Town of Simsbury

ADDENDUM #2 October 19, 2018

Project No. 18-05 Simsbury Public Library - Lower Level Improvements

M100
 DWG. NO.

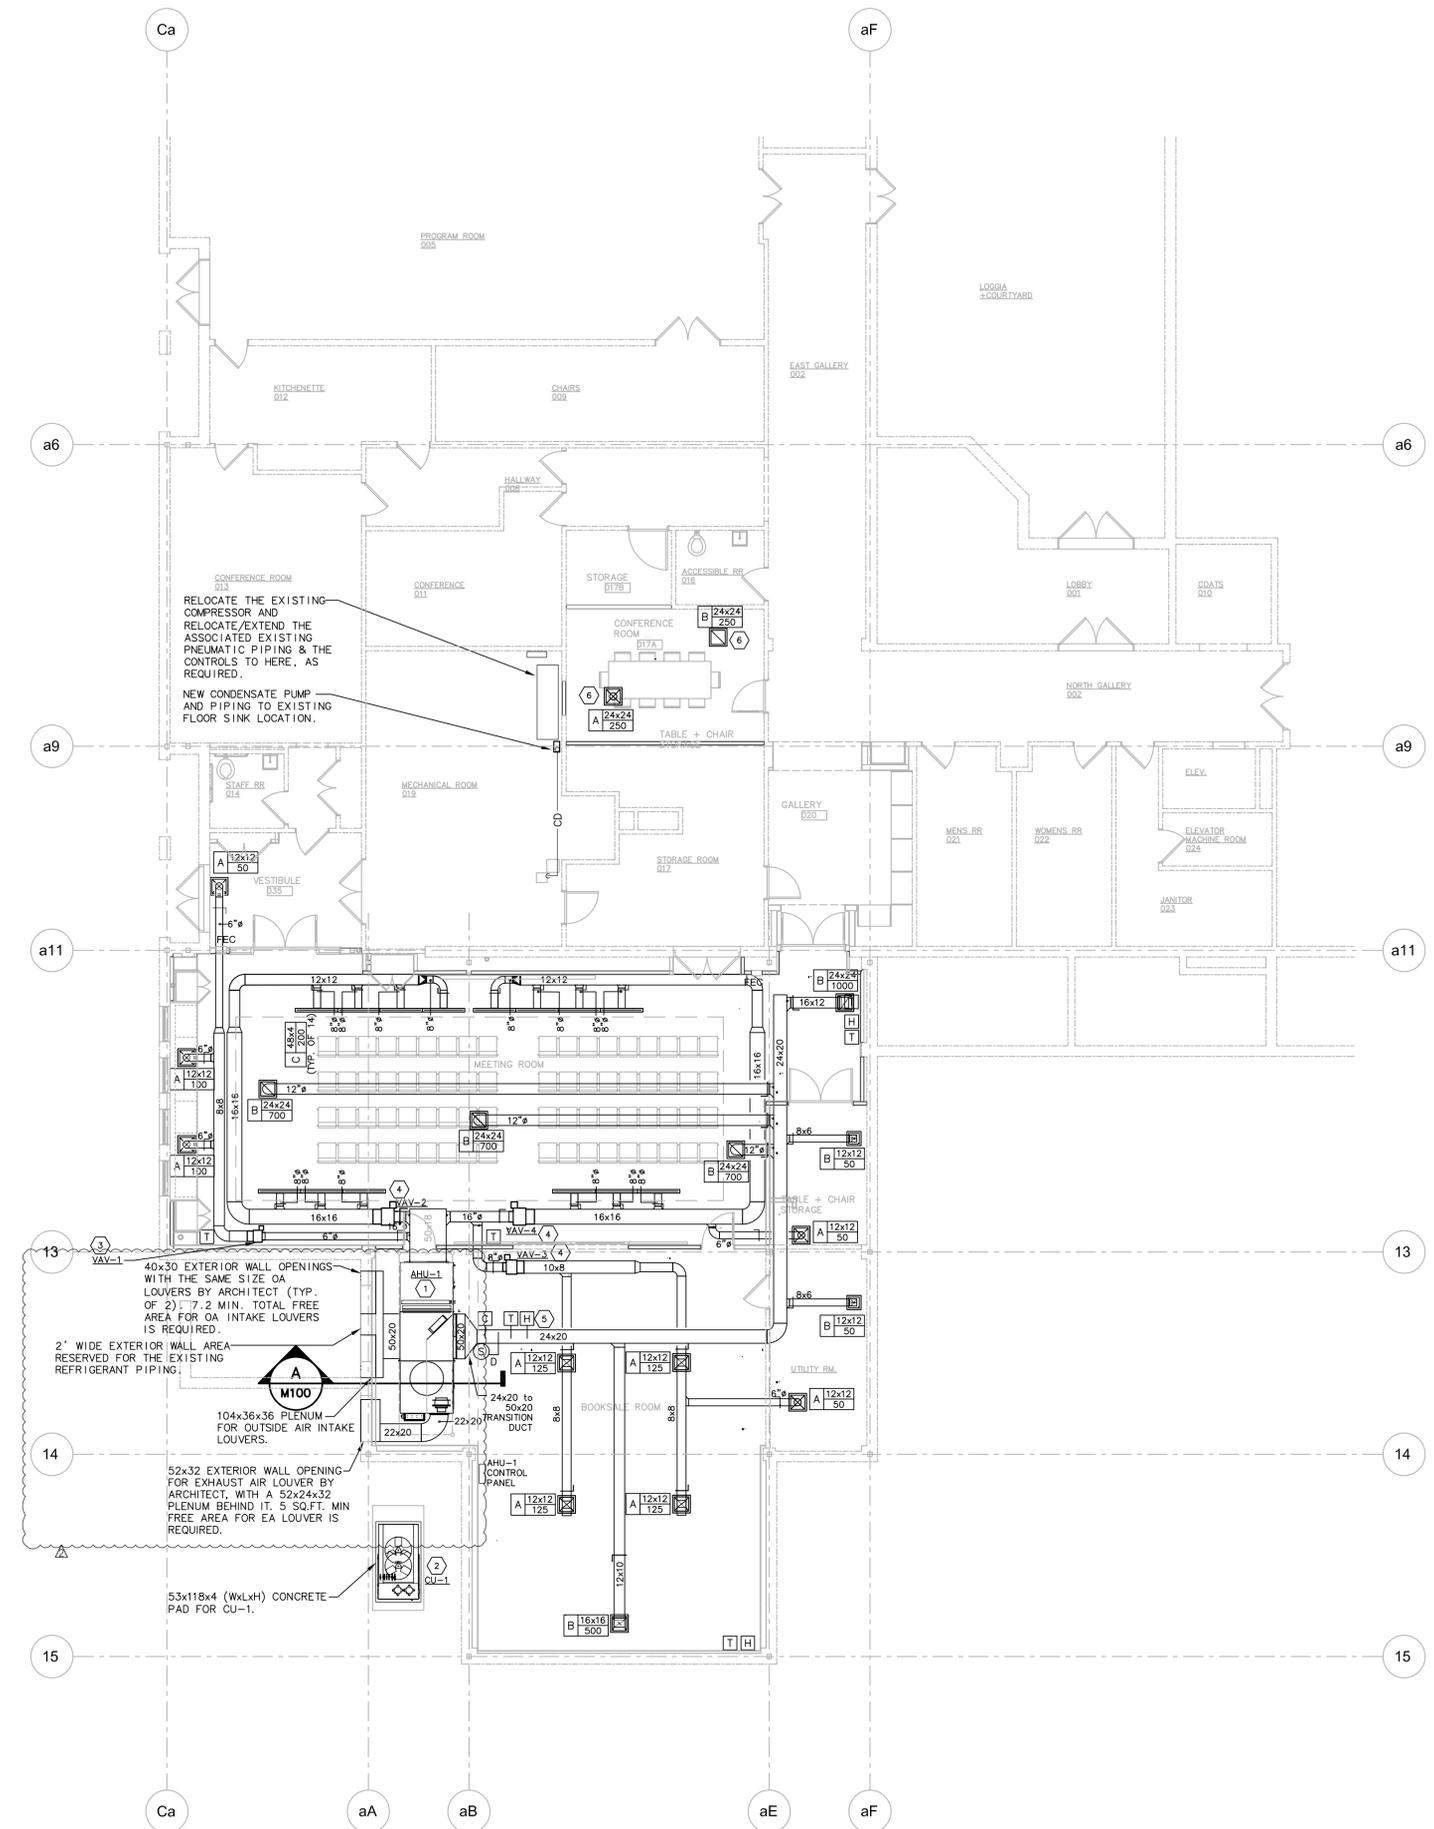
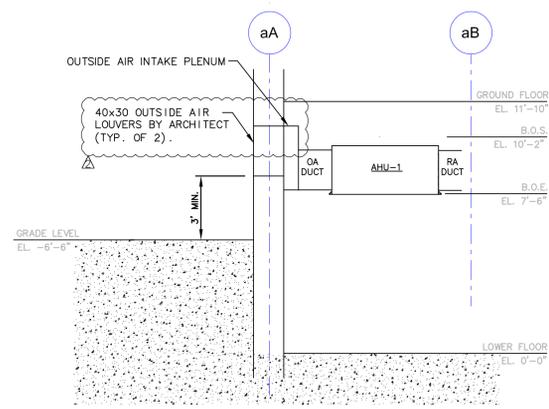
- M100 Mechanical Lower Floor Plan – New**
Replace sheet M100 with attached sheet M100, issued for Addendum #2: 19 OCT 2018.
- ED100 Electrical Lower Floor Plan – Demo**
Add General Notes – Electrical Demolition: “11. All active data cabling that runs through the area being renovated shall be existing to remain.”
